4075 El Camino Way

Response Letter to Prescreening

Notice of Incomplete/Corrections Required
Application No. 23PLN-00202
09/13/2023

Project Description: Request for a Planned Community Zone Amendment to Allow New Additions to an existing Assisted 121 Units. The New additions include 14 Additional Assisted Living Units; 5 Studios and 9 One Bedrooms. The total Project elderly in need of day-to-day care for Memory Issues. Environmental Assessment: Pending. Zoning District: PC-5116 (F) Contact the Project Planner Emily Kallas at Emily.Kallas@CityofPaloAlto.org

PROJECT:	21003
DRAWN BY:	YI, RA, & DB
CHECKED BY:	TB & MP
DATE OF ISSUE:	10/27/2022
DRAWING DESCRIPTION:	Landscape Site Plan
DRAWING NUMBER:	A1.2

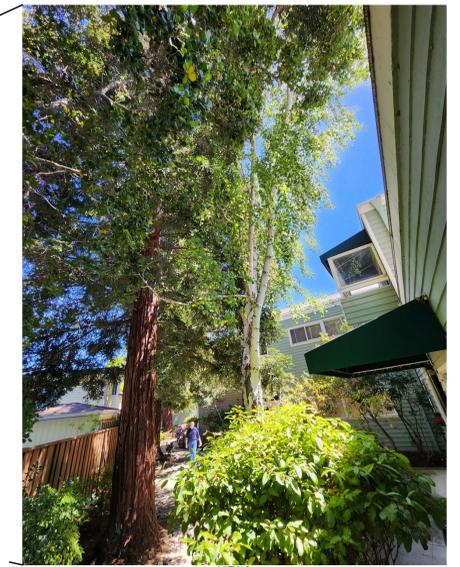
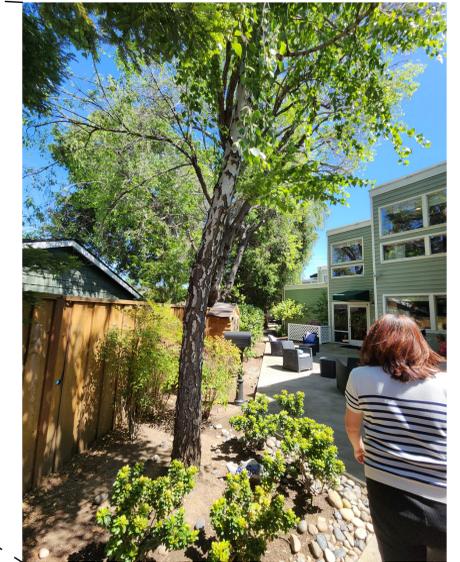
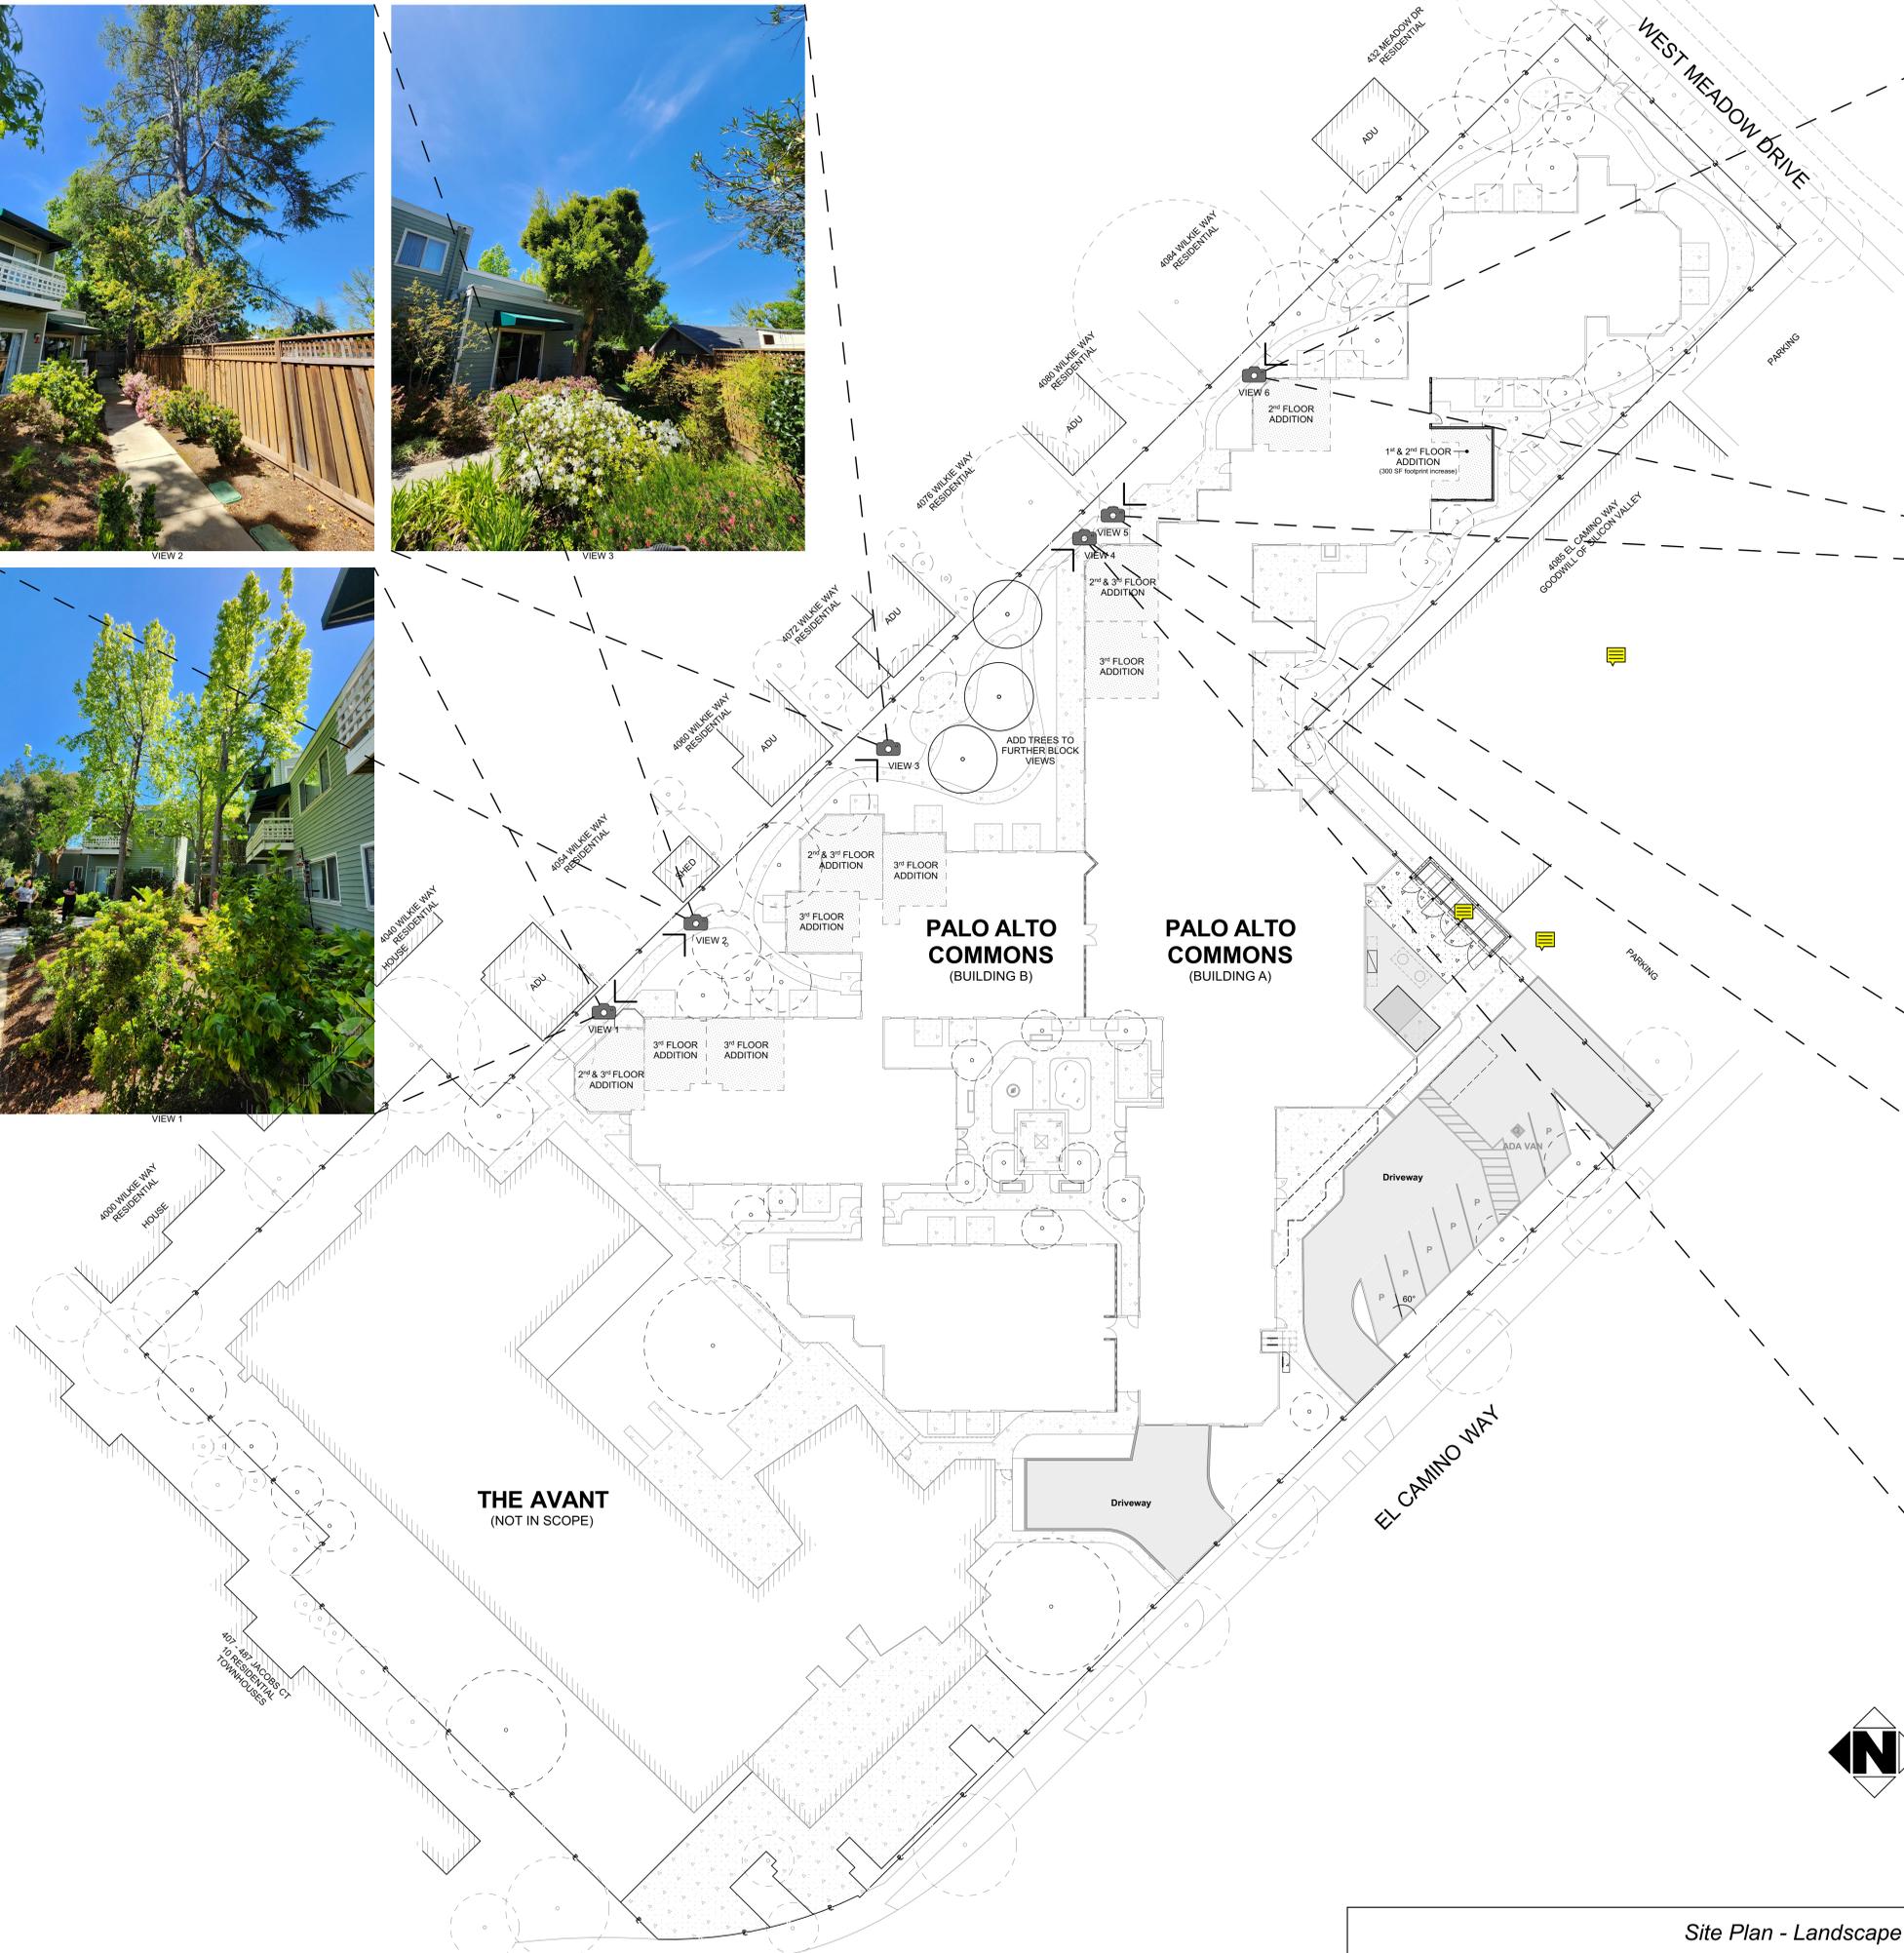
Page Reference	Annotation Type	Reviewer : Department	Review Comments	Applicant Response Comments
A1.2 Landscape Site Plan	Note	David Chung : Building	Trash enclosure is shown across PL. Clarify.	THERE IS AN EASEMENT FOR INGRESS & EGRESS AS WELL AS FOR UTILITIES. THE EXISTING TRASH ENCLOSURE IS LOCATED ON THIS EASEMENT.
A2.1 First Floor Plan Area B	Callout	David Chung : Building	Show hatching on floor plan	ADDED HATCHING TO NEW EXTERIOR WALLS
A2.2 Second Floor Plan Area A	Callout	David Chung : Building	Show hatching on floor plan	ADDED HATCHING TO NEW EXTERIOR WALLS
A2.3 Second Floor Plan Area B	Callout	David Chung : Building	Show hatching on floor plan	ADDED HATCHING TO NEW EXTERIOR WALLS
A2.4 Third Floor Plan Area A	Callout	David Chung : Building	Show hatching on floor plan	ADDED HATCHING TO NEW EXTERIOR WALLS
A2.5 Third Floor Plan Area B	Callout	David Chung : Building	Show hatching on floor plan	ADDED HATCHING TO NEW EXTERIOR WALLS

A1.2 Landscape Site Plan	Note	Stephanie Lau : Zero Waste	<p>The refuse hauler, GreenWaste of Palo Alto has concerns regarding to the access and service for the current proposed refuse enclosure location. Please provide the path of travel with the measurements for the egress, ingress, path of travel, and the turning radius (especially for the turn near the exit). The path-of-travel for the refuse trucks must have a 22' wide driveway (ingress and egress), a 16' tall overhead clearance along the full path, a 12' wide impervious path-of-travel, and a minimum outer turning radius of 40' and a minimum inner turning radius of 28.4'. Due to safety, the refuse trucks will not be able to back up out of the property, the refuse truck must be able to drive through the lot.</p> <p>The site has the following options:</p> <ol style="list-style-type: none"> 1. Have an onsite refuse enclosure that will fulfill all the path of travel requirements above and ensure that the refuse containers can be serviced within 25 feet from the refuse enclosure. 2. Move the refuse enclosure within 25 feet from the curb. 3. Propose a staging area that is serviceable within 25 feet from the curb or within 25 feet at an onsite location that is serviceable by the refuse hauler. Please note, onsite personnel will be required to pull out the bins for service and quickly put the bins back into the refuse enclosure. The staging must be approved by the refuse hauler, and a sign indicating "no parking" during refuse service hours are required. Please add notes onto the plan set. 4. *Please note, pull-out charges would apply to service locations between 25' to 125' from the bin service location. The refuse hauler will not service refuse bin locations that are beyond 125'. <p>Please contact Alex Cushing, alex.cushing@greenwaste.com from GreenWaste of Palo Alto to further discuss service location options.</p>	<p>A1.2: ADDED REFUSE HAULER PATH OF TRAVEL ON OUR SITE. IT REACHES WITHIN 25' OF THE REFUSE ENCLOSURE PROVIDE TURNING RADIUS AND REQUIRED WIDTH</p> <p>WHEN WE CONTACTED ALEX CUSHING AT GREEN WASTE HE SAID, "I confirmed with Eric that although the turn radius plans could potentially work, it leaves little to no room for flexibility or error especially if other vehicles are in the lot. Considering the parking lot plans remain unchanged from how they currently are, our drivers will still be unable to drive through the lot. Although it is not ideal, we can continue to pull in for service and reverse out onto El Camino Way"</p>

**Third Floor Plan
Area B**

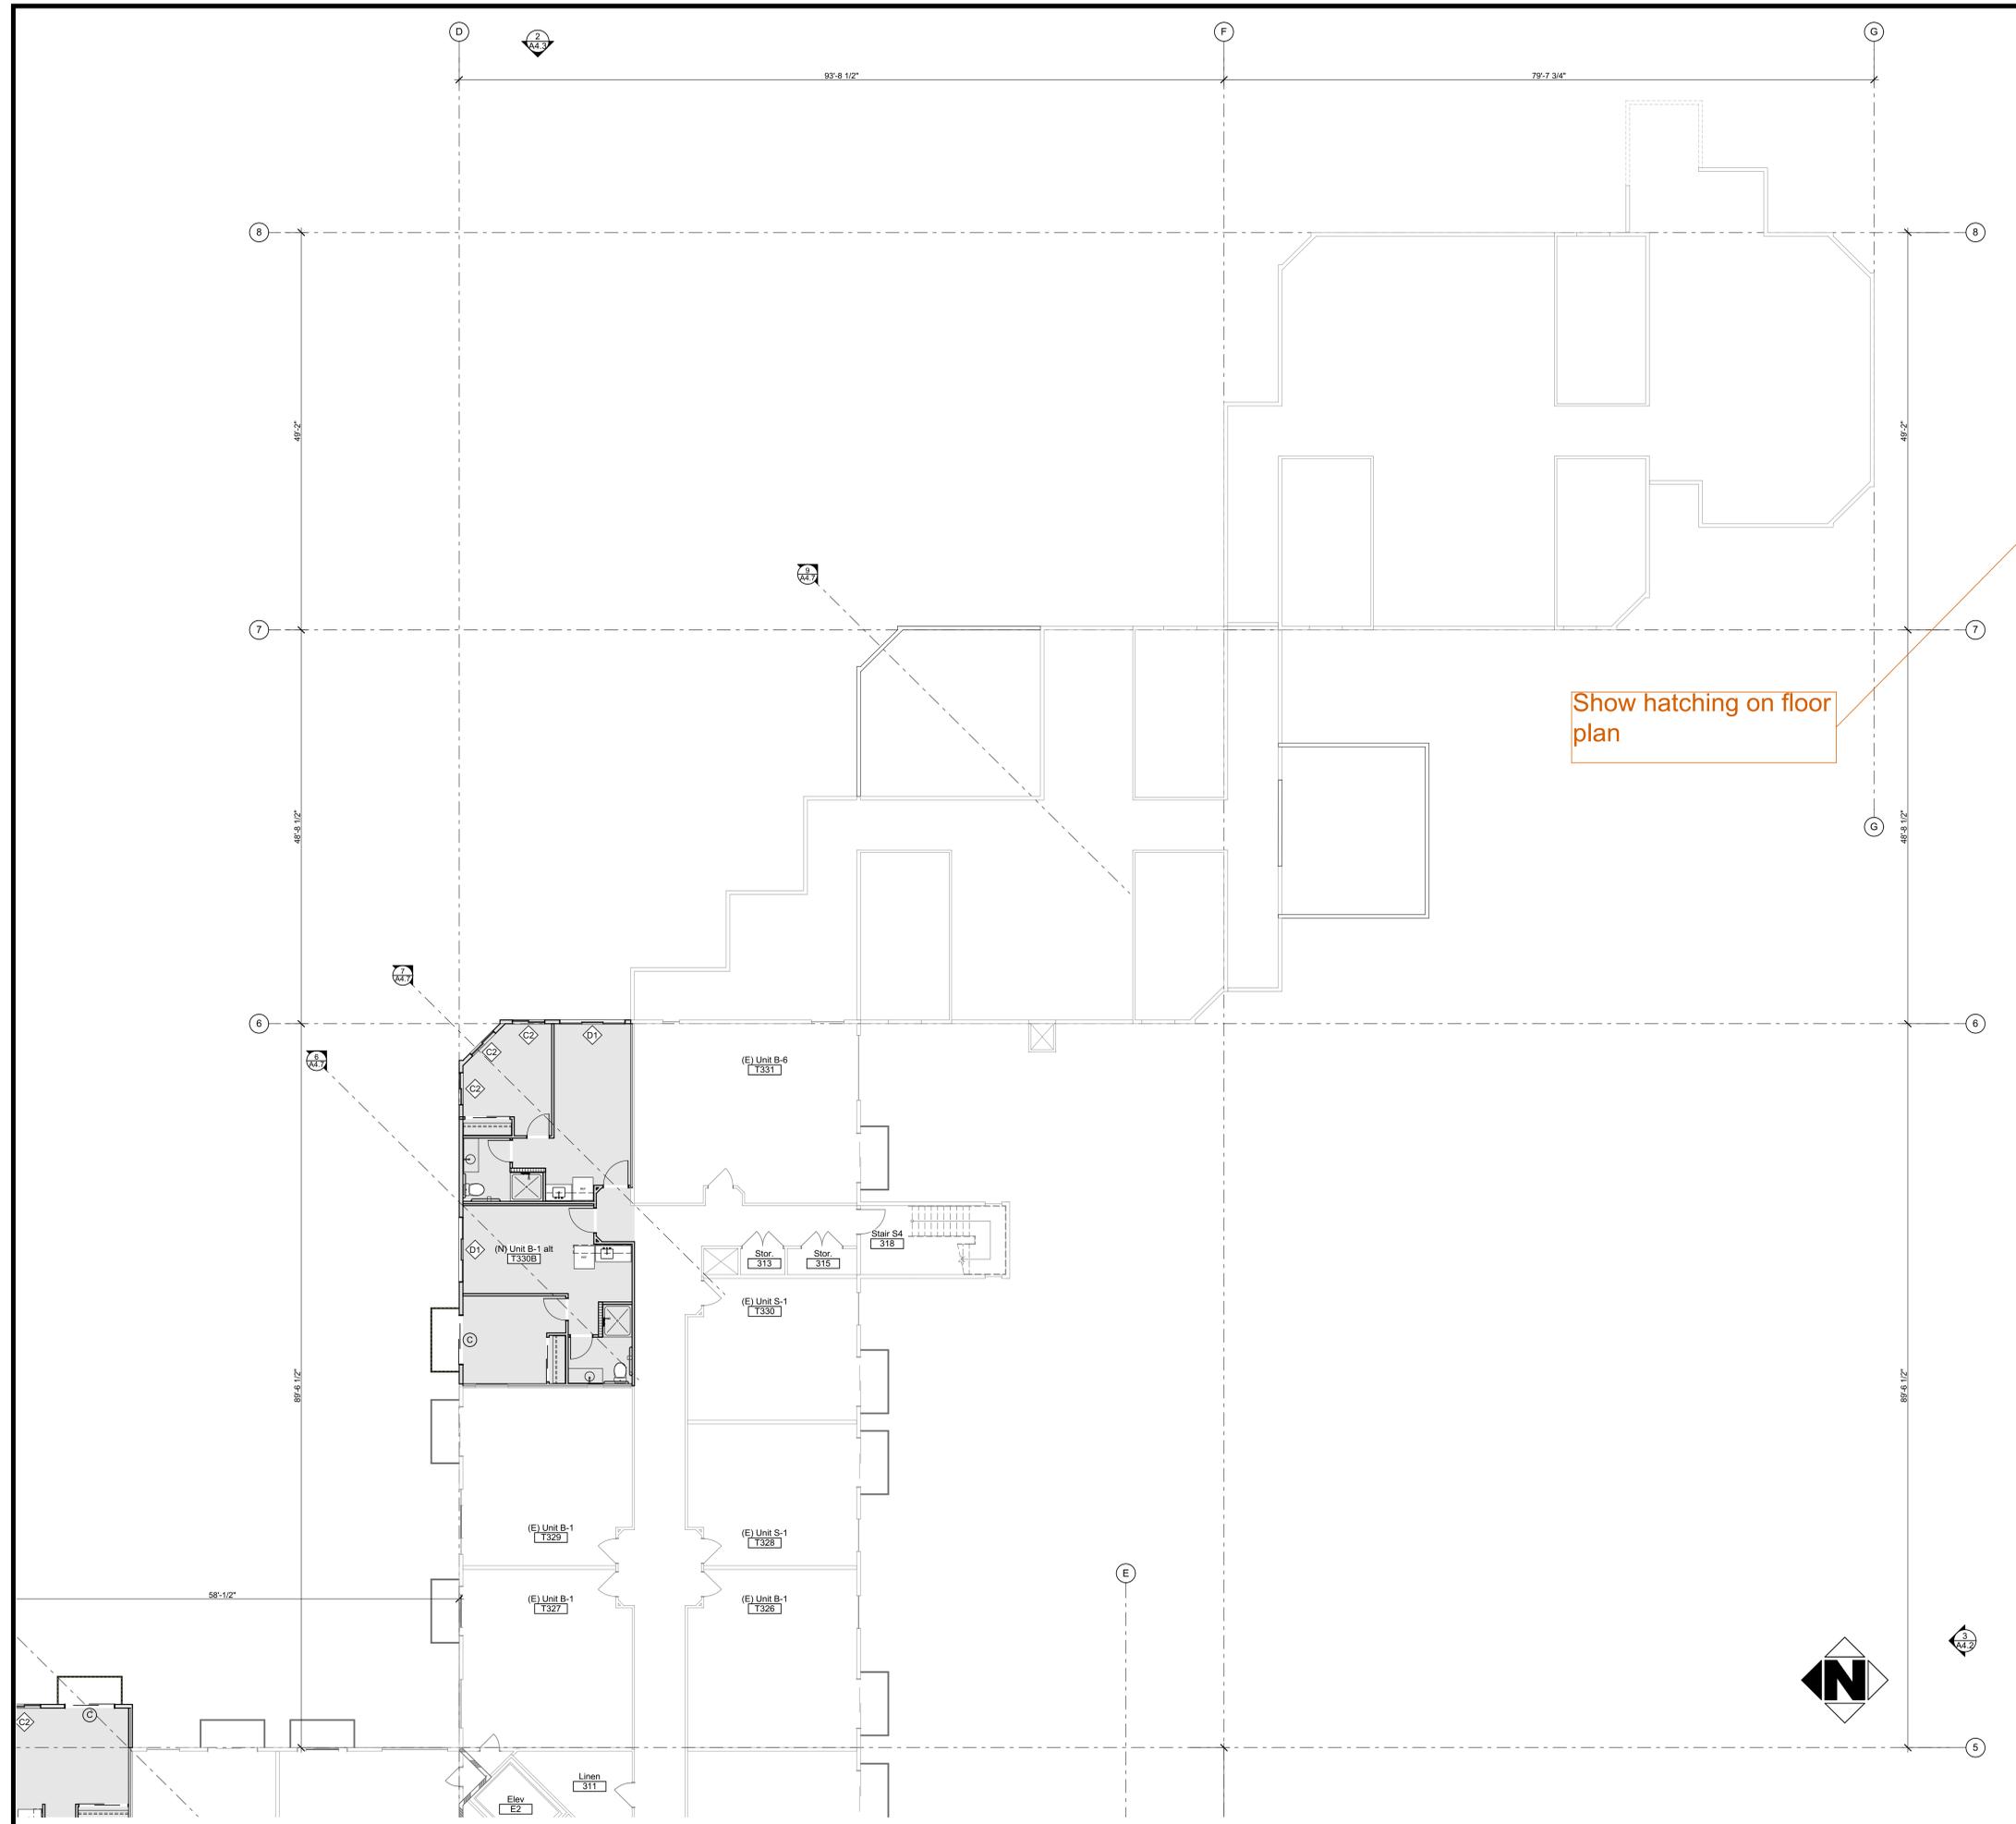
Show hatching on floor plan
